DESIGN REVIEW - 1760 NW 56th STREET

1760 NW 56th St, Seattle, Washington  
DPD Project #3012436

BALLARD INVESTMENT PARTNERS, LLC  
ANKROM MOISAN ASSOCIATED ARCHITECTS  
June 05, 2012

DESIGN GUIDANCE THEME 2: East Facade Treatment

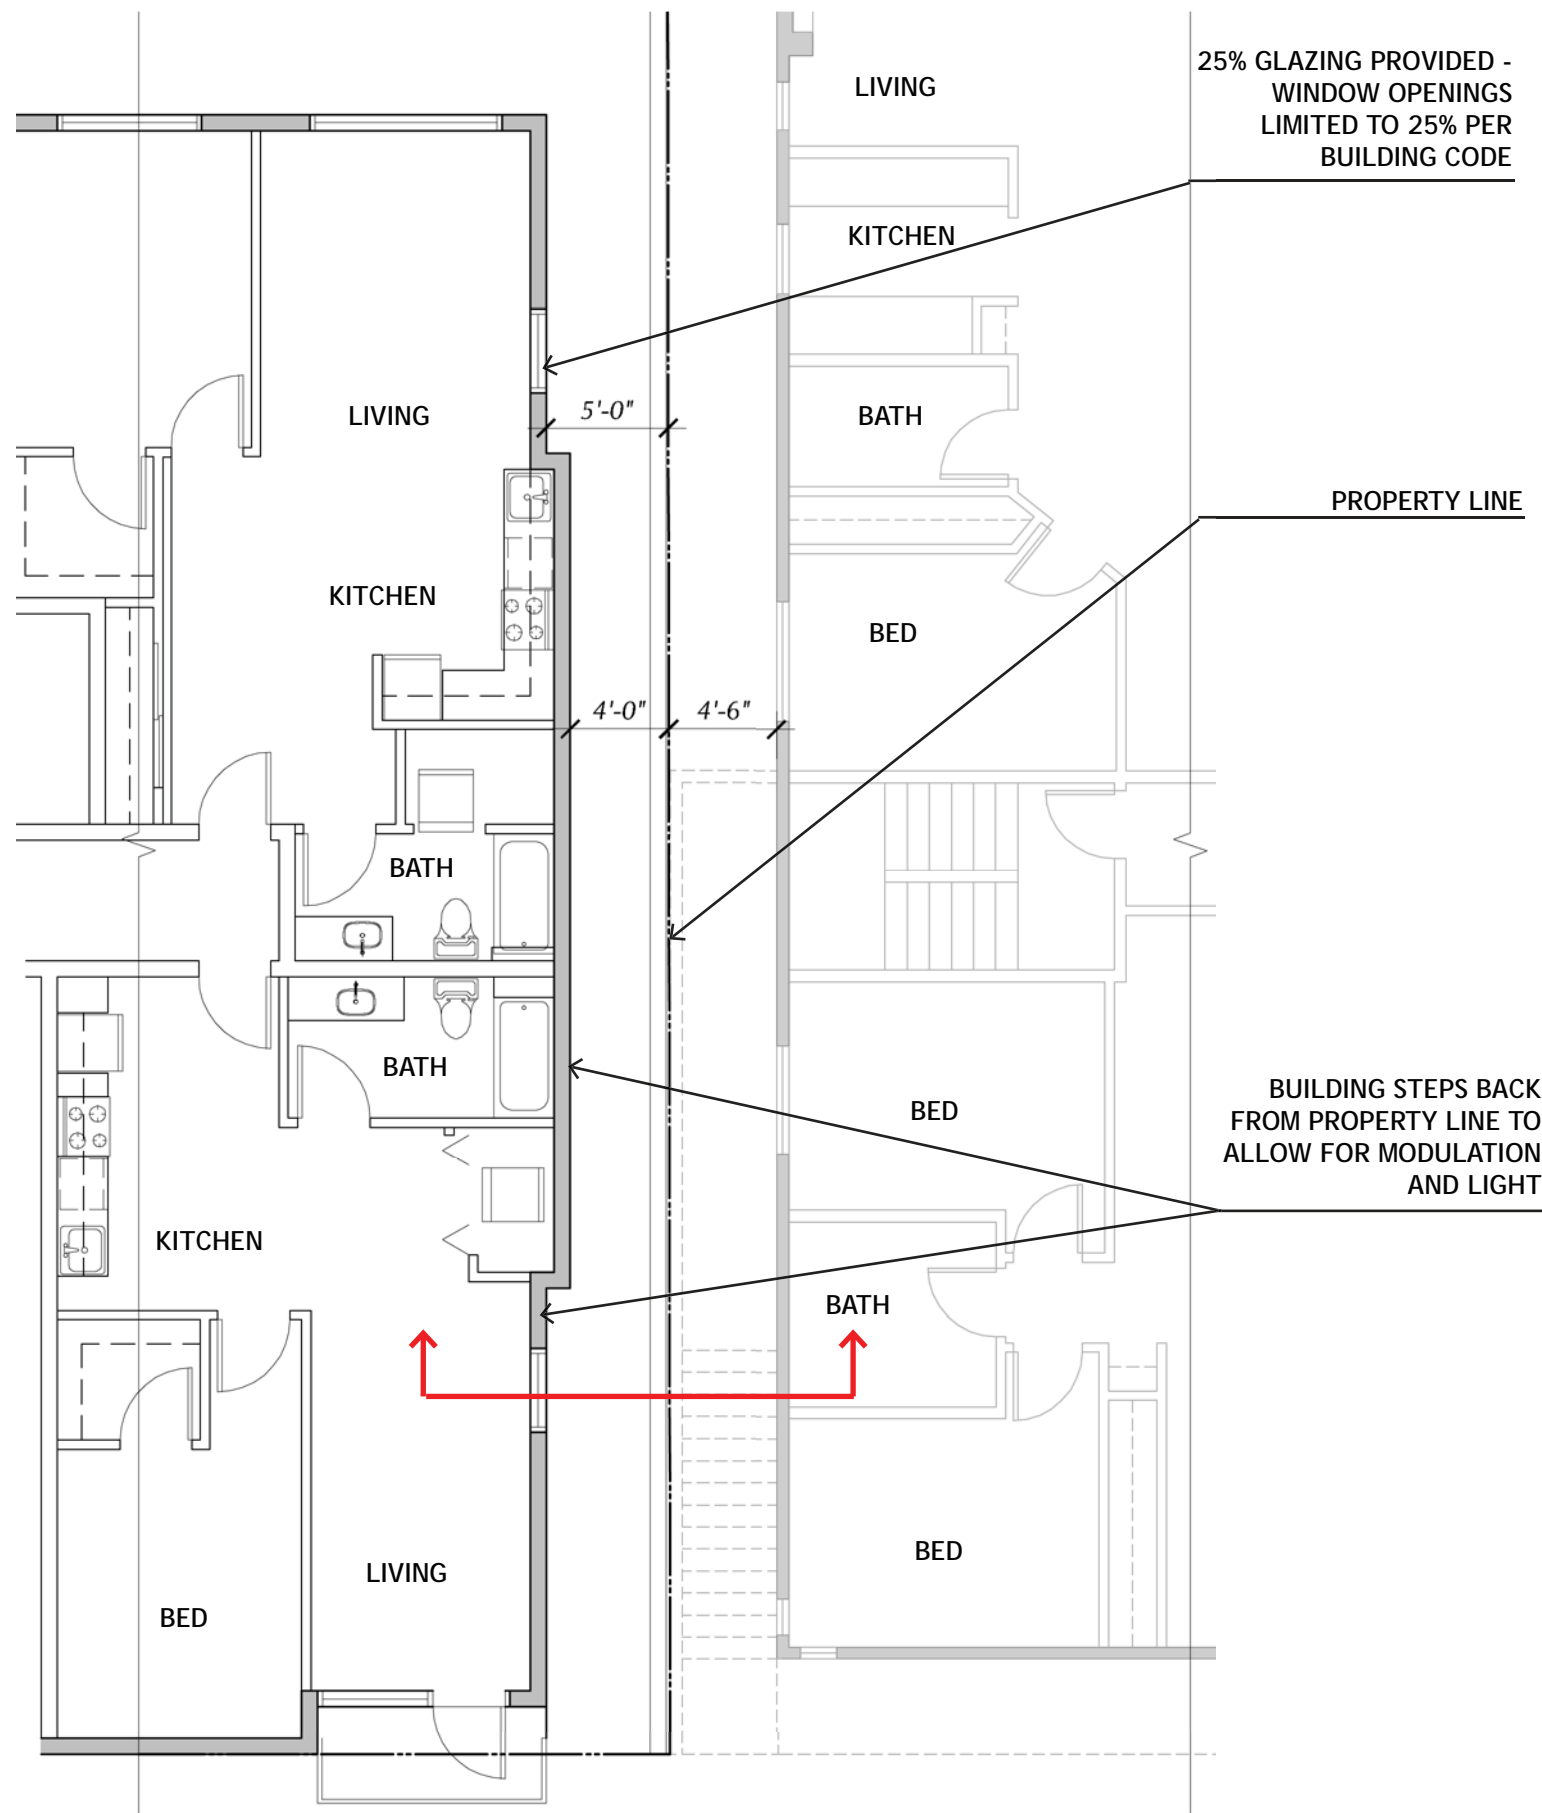
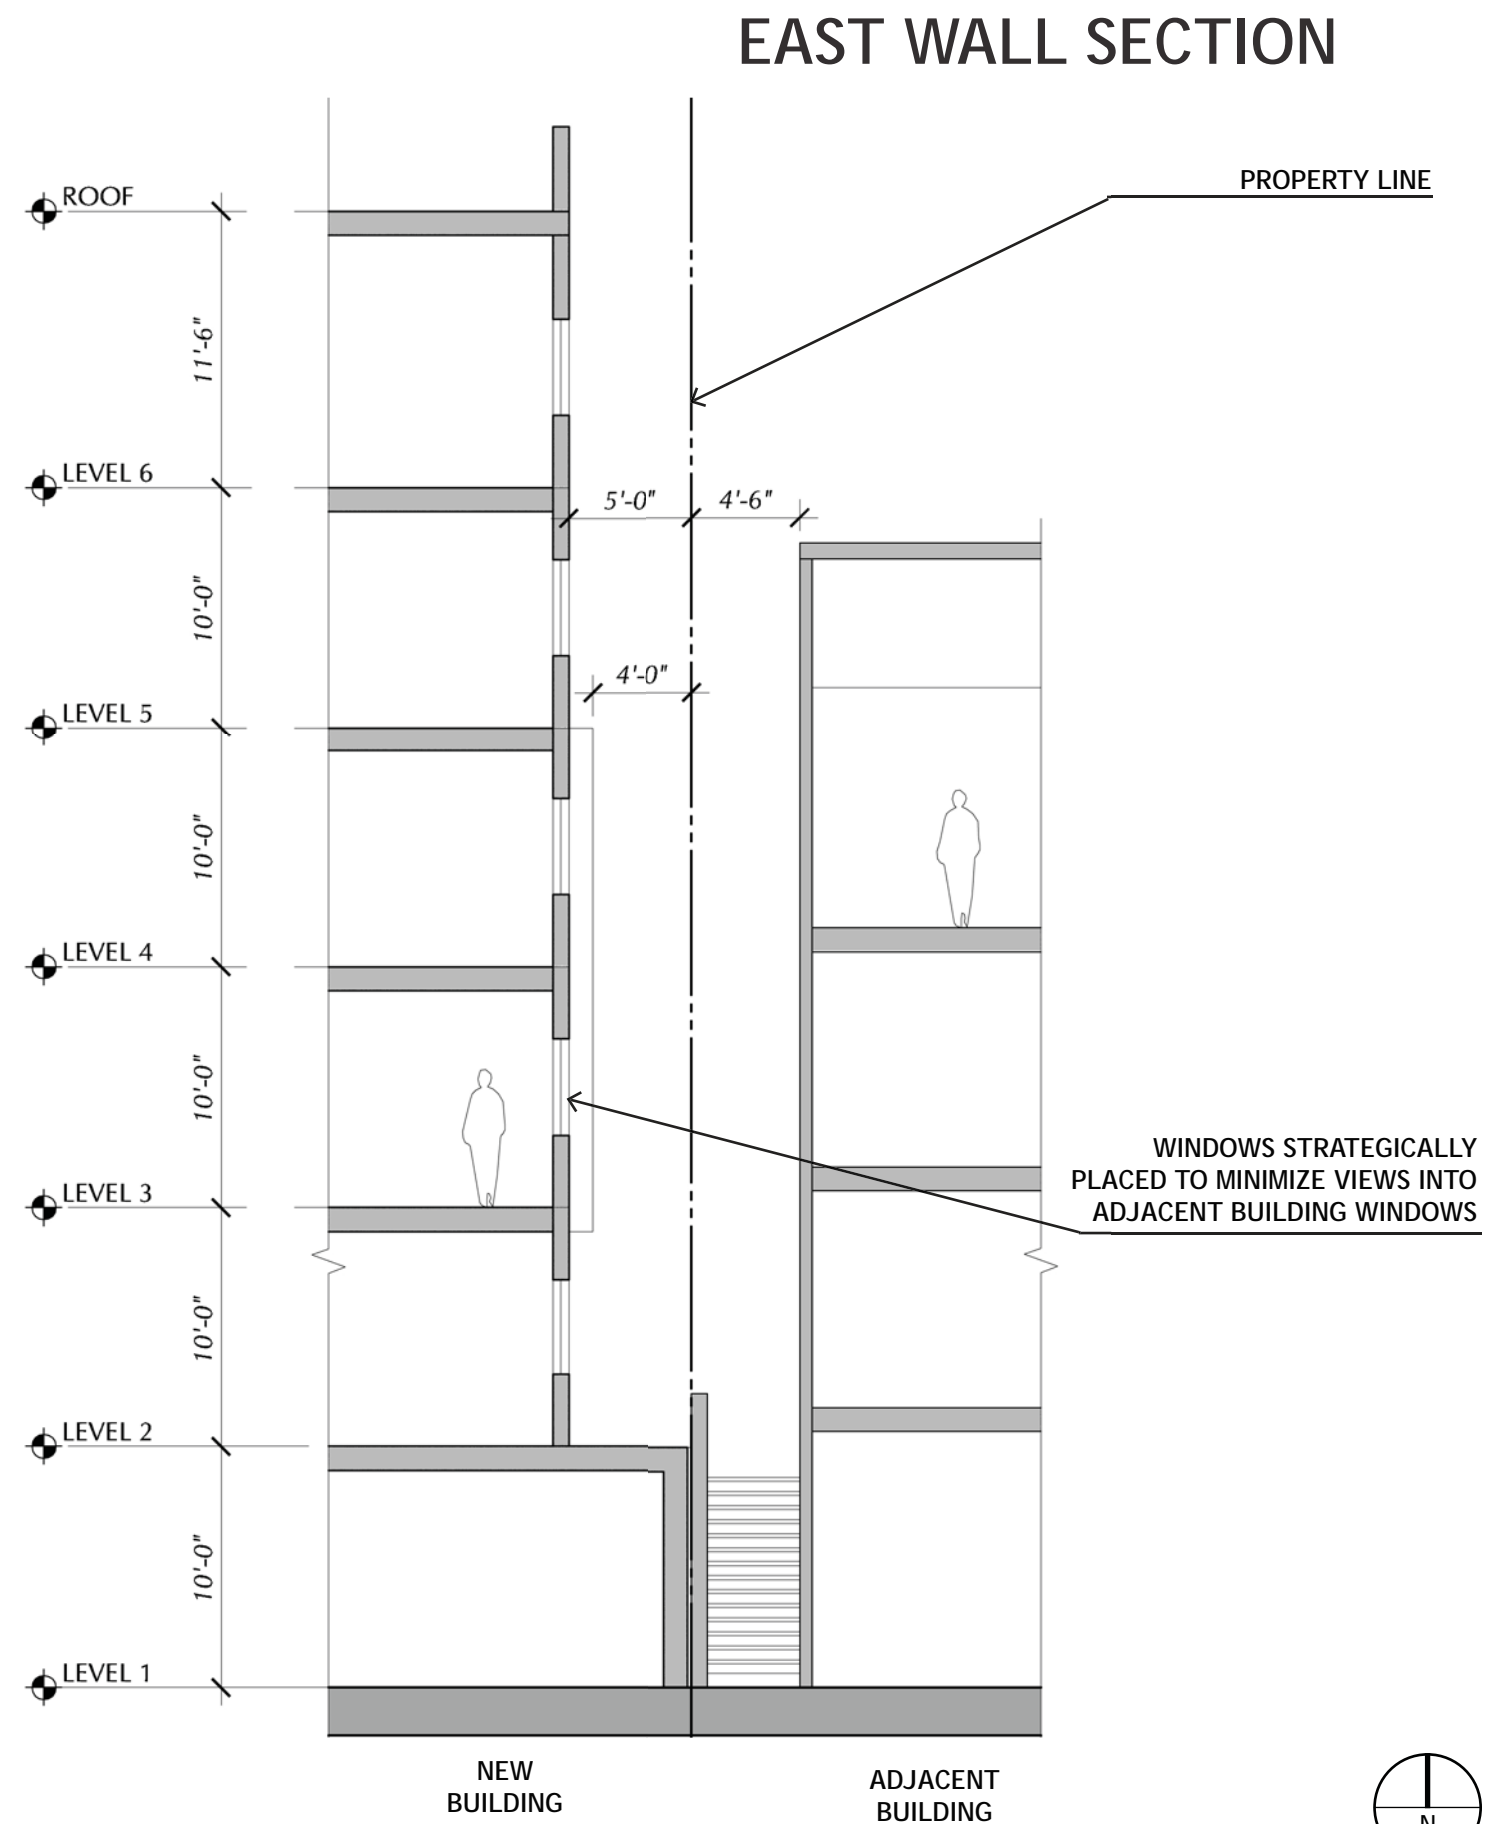
*" The board appreciated the effort to keep the building profile narrow and less bulky."*

*" . . blank wall treatment to address scale concerns."*

*" . . material, texture, color and patterning of this facade . ."*

EAST FACADE - VIEW FROM STREET LEVEL

SECTION THRU EAST WALL
